**Committee of Experts on the Transport of Dangerous Goods  
and on the Globally Harmonized System of Classification  
and Labelling of Chemicals****Sub-Committee of Experts on the Transport  
of Dangerous Goods****Fortieth session**

**Updating of the Globally Harmonized System of  
Classification and Labelling of Chemicals (GHS):  
physical hazards****Amendments to the classification flow chart/decision logic for  
self-reactive substances and organic peroxides****Transmitted by the International Council of Chemical Associations  
(ICCA)<sup>1</sup>****I. Introduction**

**Figure 2.4.1: Flow chart scheme for self-reactive substances**

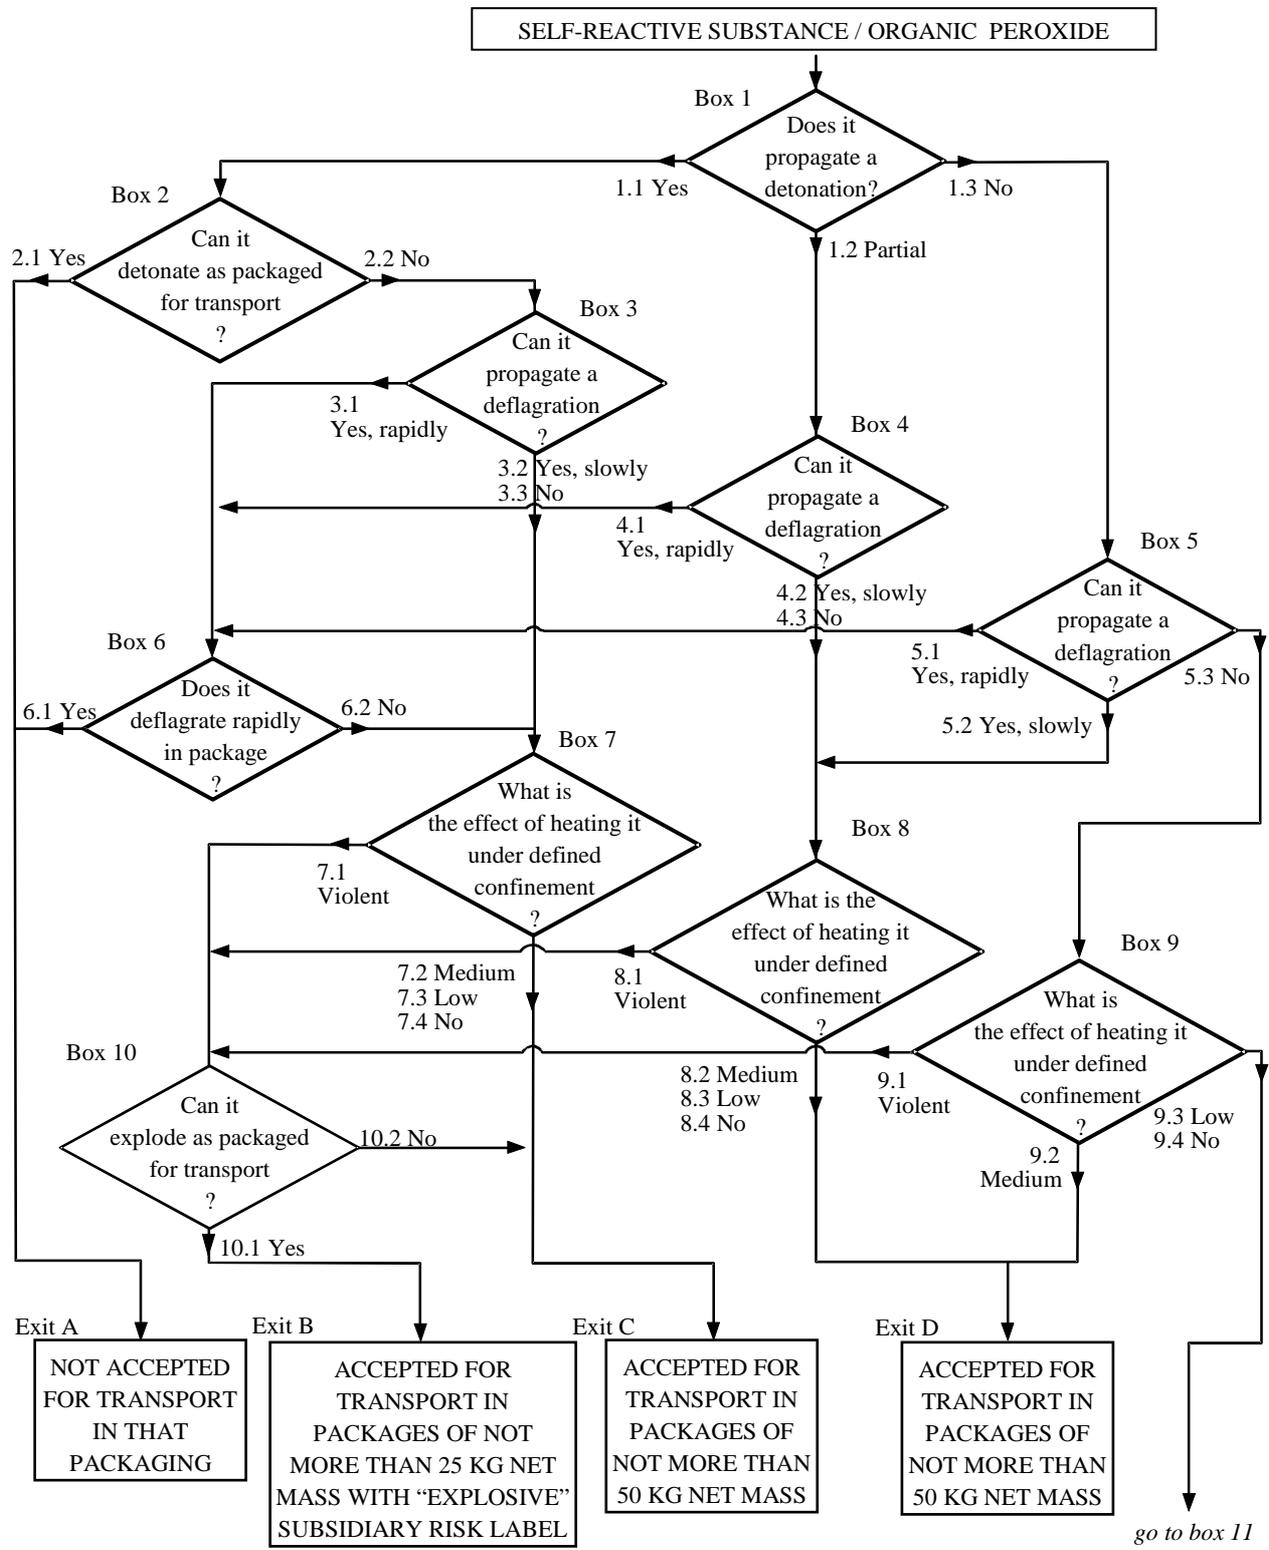
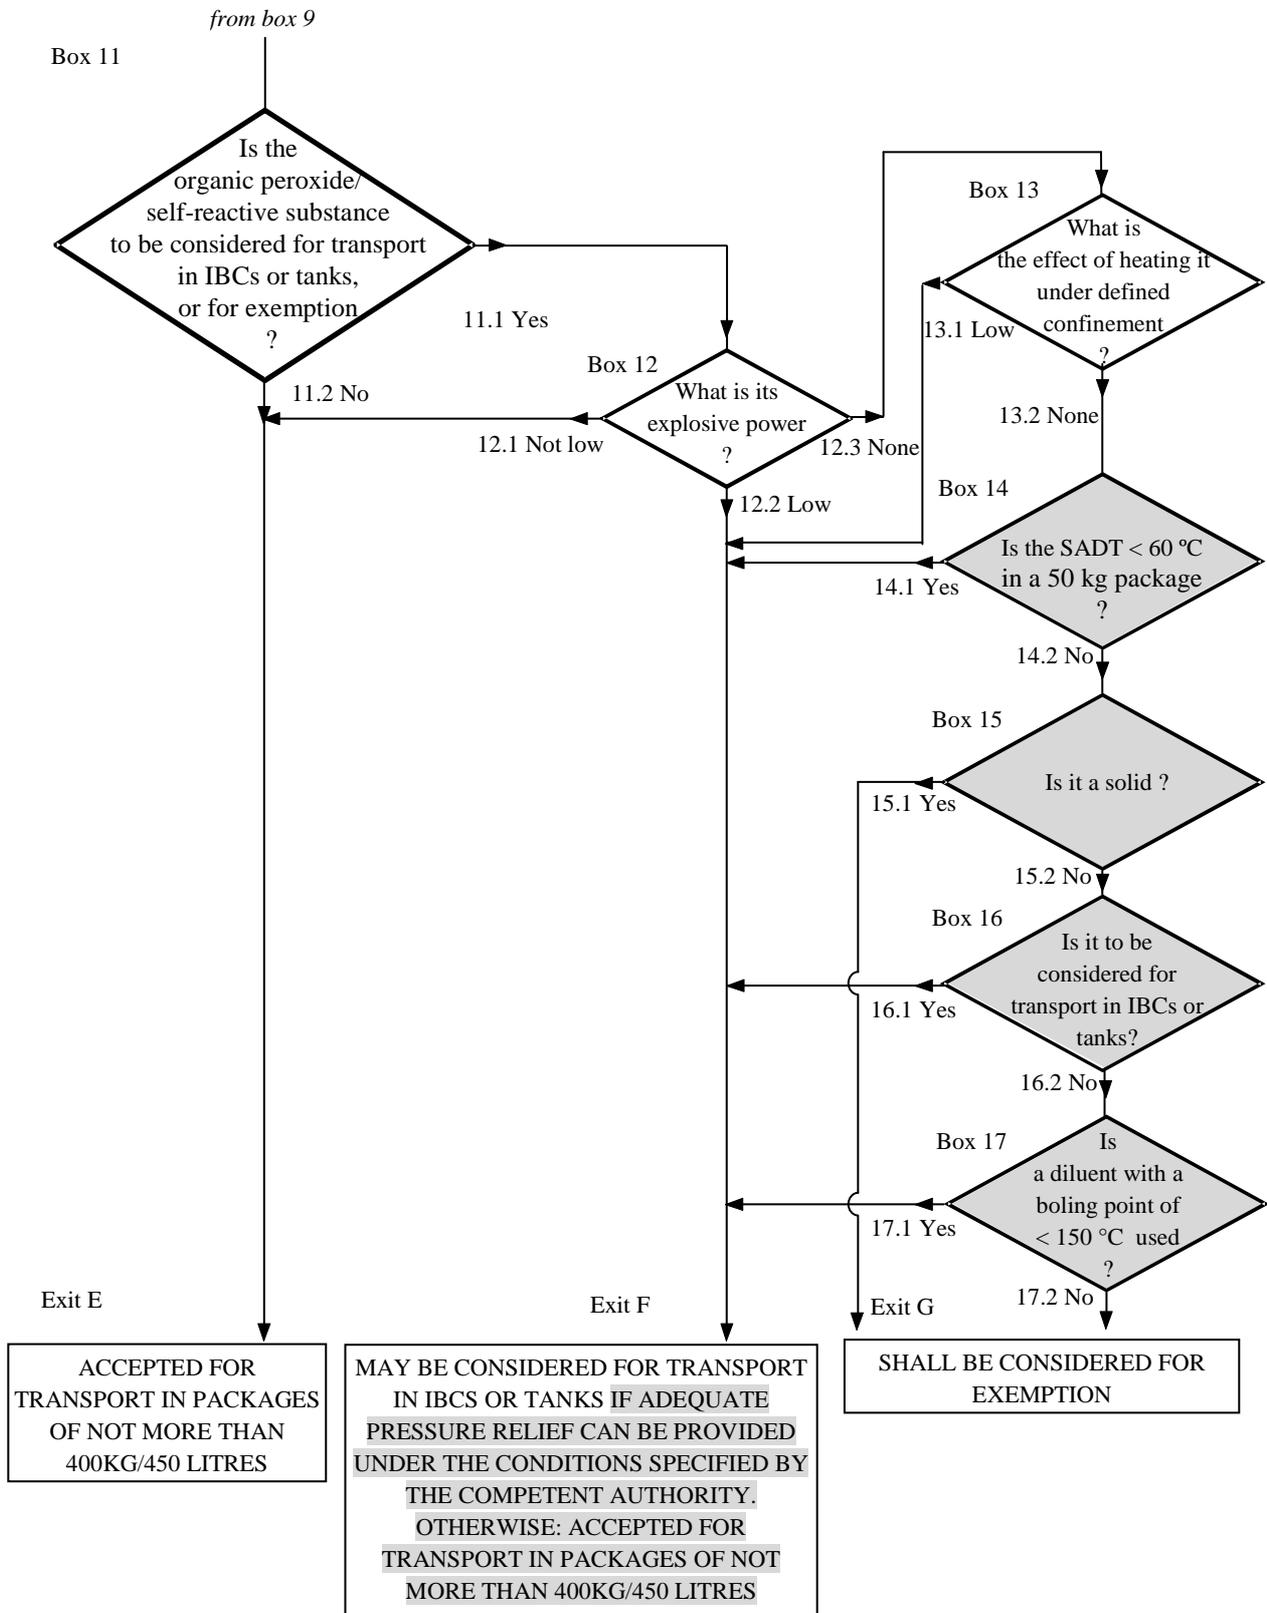
6. In the proposed amended flow chart these two aspects are addressed in the new boxes 14 and 17 respectively. The introduction of these boxes will not lead to a change in the existing classification principles.

8. In the proposed amended flow chart these two aspects are addressed in the new boxes 15 and 16 and the wording in exit F (in flow chart Model Regulations).

9. Based on the background given in sub-sections 2.1 (no change in classification principles) and 2.2 (change in classification principles for Type G substances) the following is proposed (changes in grey shading):

(a) In the Model Regulations replace Figures 2.4.1 and 2.5.1 by the following new scheme:

10. Based on the background given in sub-section 2.1 (no change in classification principles), it is proposed to take proposal alternative 1 with the deletion of boxes 15 and 16 and deleting the grey shaded wording in exit F of the proposed flow chart scheme in paragraph 9 (a) (i.e. proposal for the Model Regulations).

**Decision logic 2.8 for self-reactive substances and mixtures**  
**Decision logic 2.15 for organic peroxides**

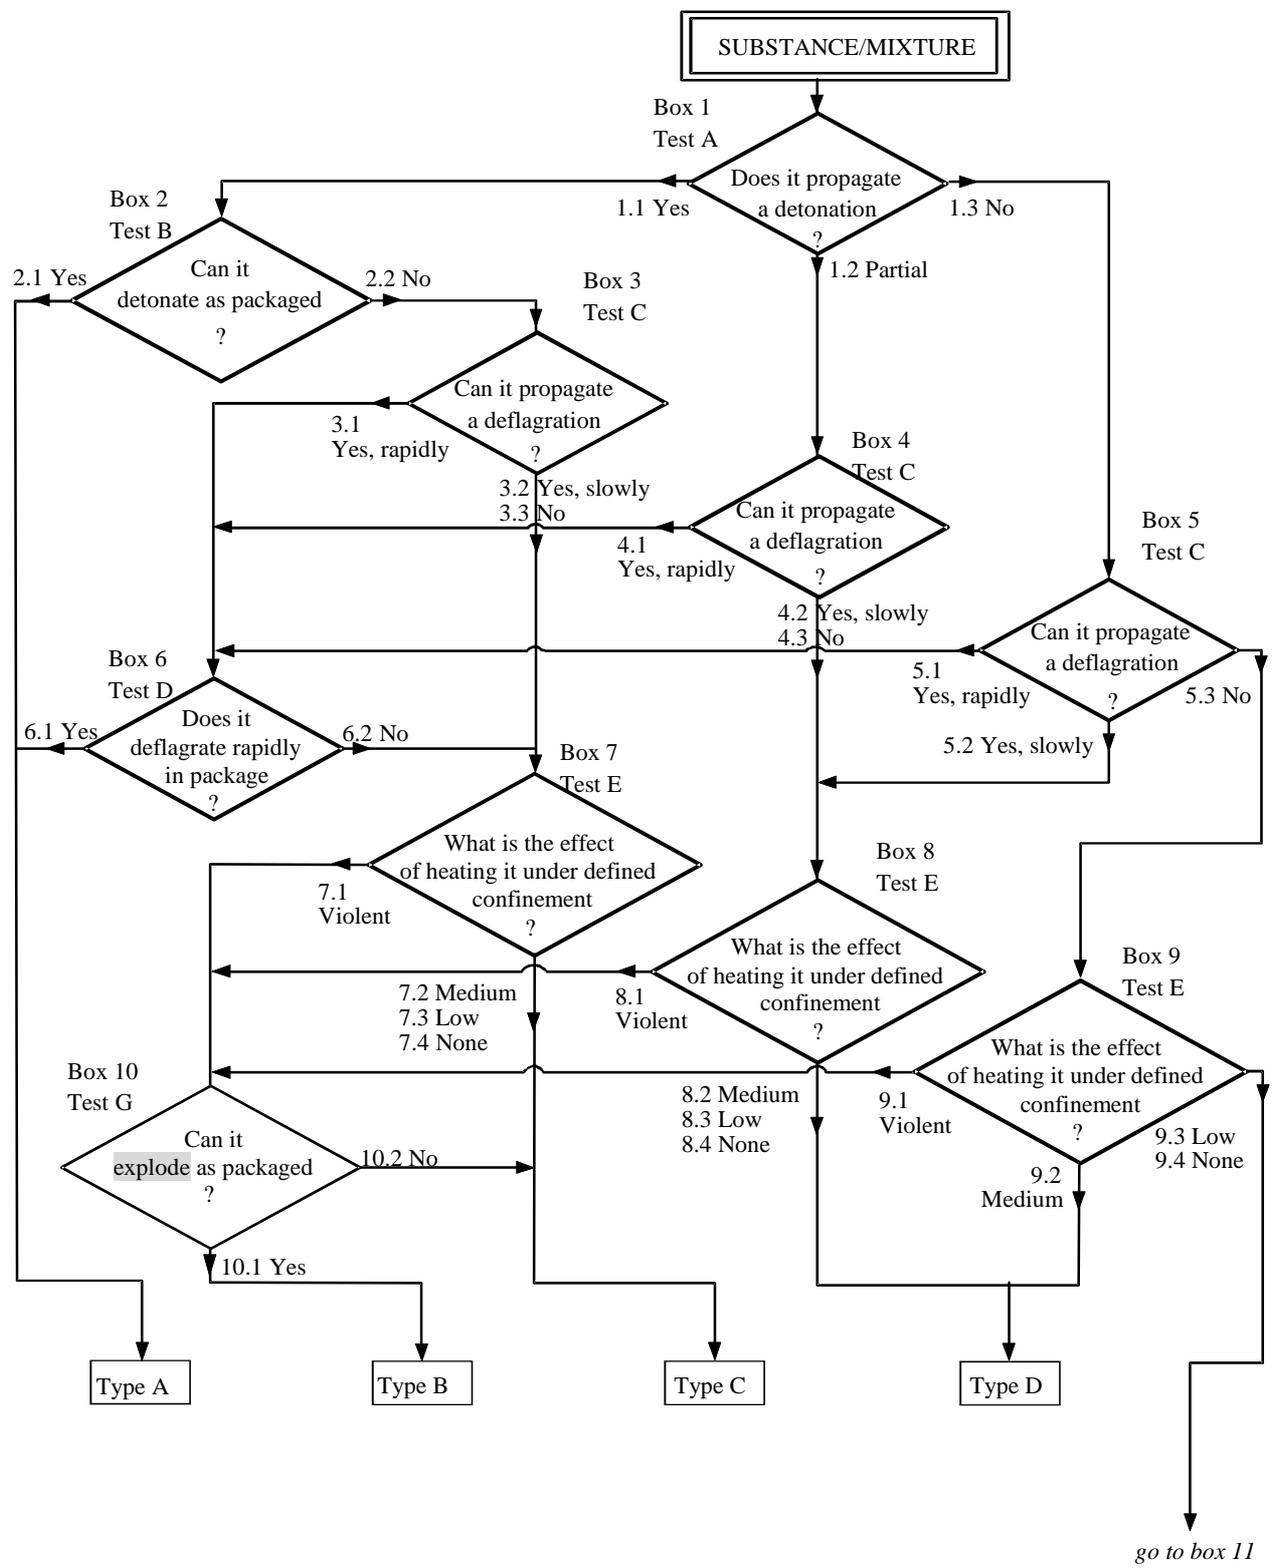
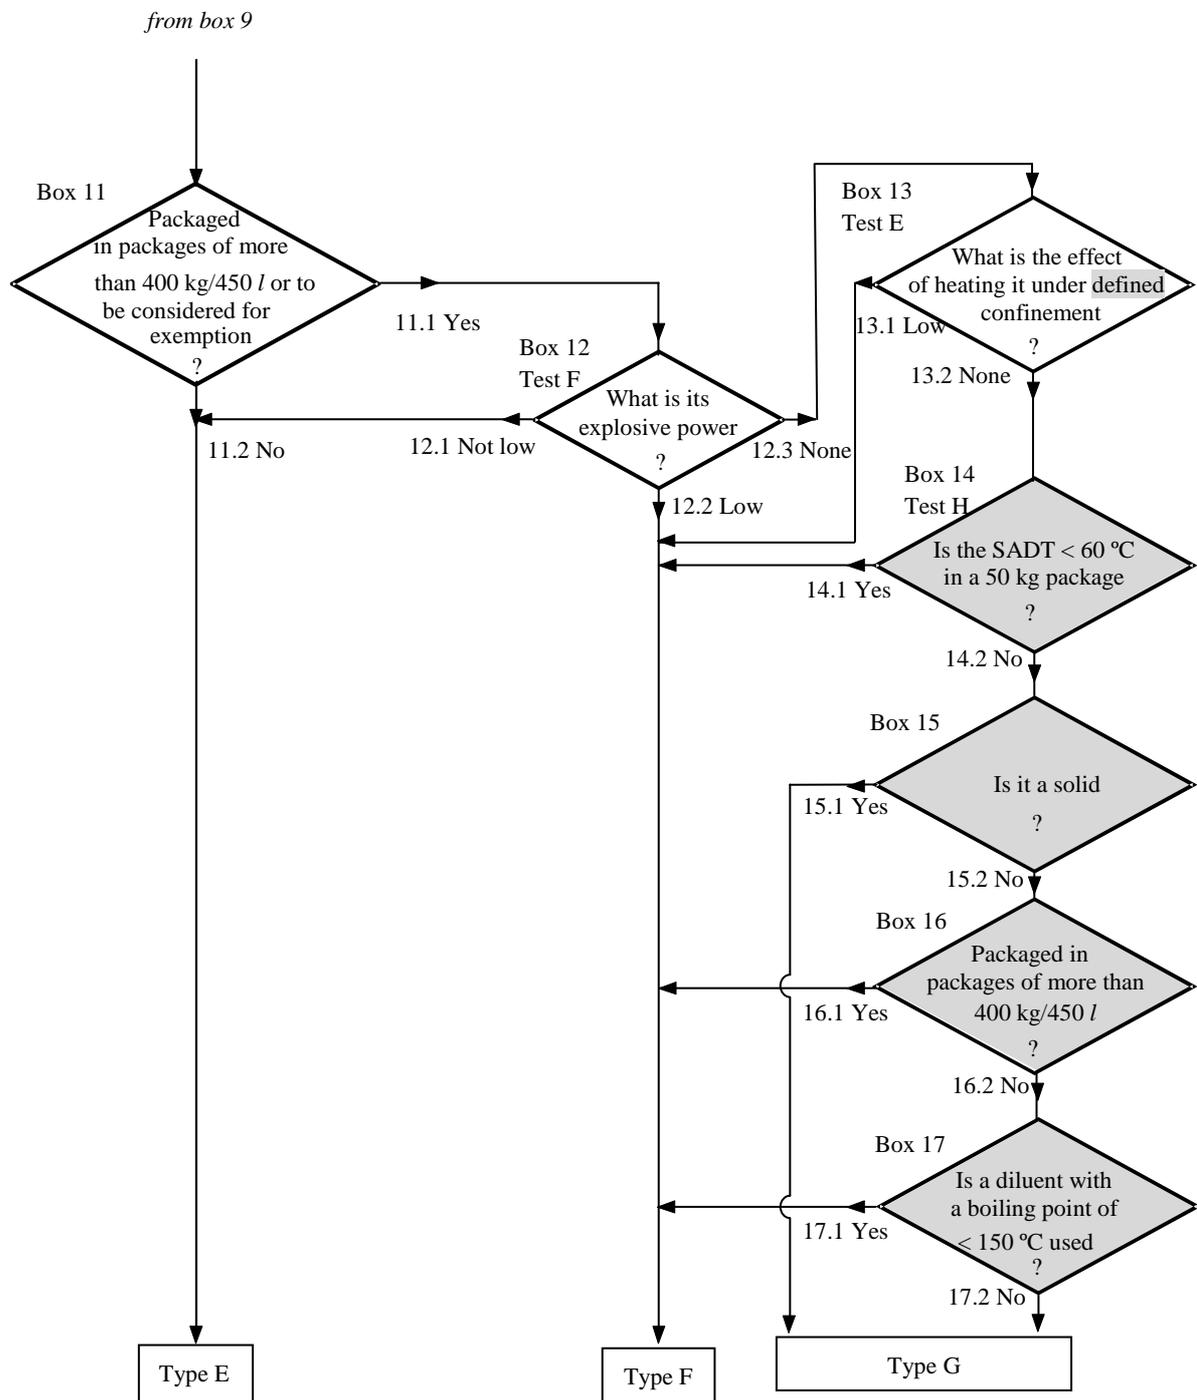
(b) In GHS replace Figures 2.8 and 2.15 by the following new decision logic:

(Note: the grey shaded wording in boxes 10 and 13 are just corrections.)
